Access Compliance Report Public Rights-of-Way (Curb Ramps)

Main Street: LOMA_LINDA_WAY Cross Street: LA_LOMA_DR Location: W

ADA ID: RPRK211012125228 Ramp Type: Type 4 - Parallel Initial Pass/Fail: Fail Overall Compliance: No Severity Score: 2

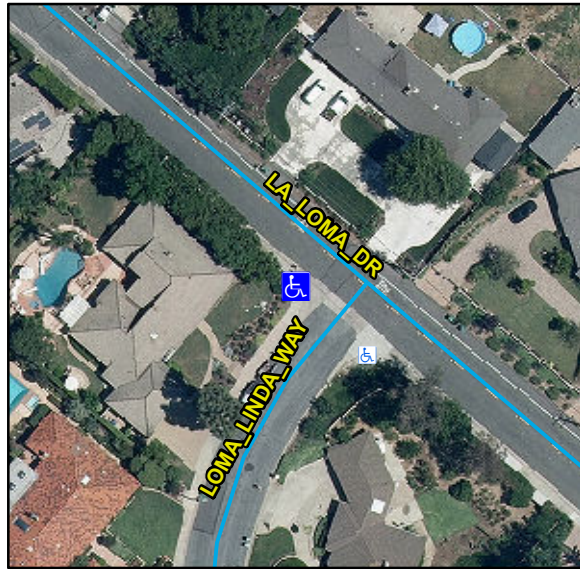
Compliance	Description	Data	Compliance	Description	Data
N/A	Ramp Length LT (in)	130	N/A	Ramp Length RT (in)	126
Yes	Ramp Width LT (in)	68	Yes	Ramp Width RT (in)	58
Yes	Ramp Run Slope LT (%)	3.1	Yes	Ramp Run Slope RT (%)	5.5
No	Ramp Cross Slope LT (%)	3.4	No	Ramp Cross Slope RT (%)	3
N/A	Landing Present	N/A	N/A	DWS Provided	N/A
N/A	Landing Length (in)	N/A	N/A	DWS Contrast	N/A
N/A	Landing Width (in)	N/A	N/A	DWS Length (in)	N/A
N/A	Landing Run Slope (%)	N/A	N/A	DWS Full Width	N/A
N/A	Landing Cross Slope (%)	N/A		DWS Offset Type	N/A
N/A	Landing Movement Obstructed?	N/A	N/A	DWS Offset Left (in)	N/A
	Landing Movement Type	N/A	N/A	DWS Offset Right (in)	N/A
N/A	Landing Shared	N/A			
N/A	Clear Space	Yes			
N/A	Clear Space To Crosswalk (in)	N/A			
N/A	Marked Crosswalk 1	No	N/A	Marked Crosswalk 2	No
	Crossing 1 Direction	SE		Crossing 2 Direction	NE
	Marked Crosswalk 1 Width (in)	N/A		Marked Crosswalk 2 Width (in)	N/A

Remove & Replace Curb Ramp With Two New Directional Ramps or Equivalent.

R304.5.3, STD 1115
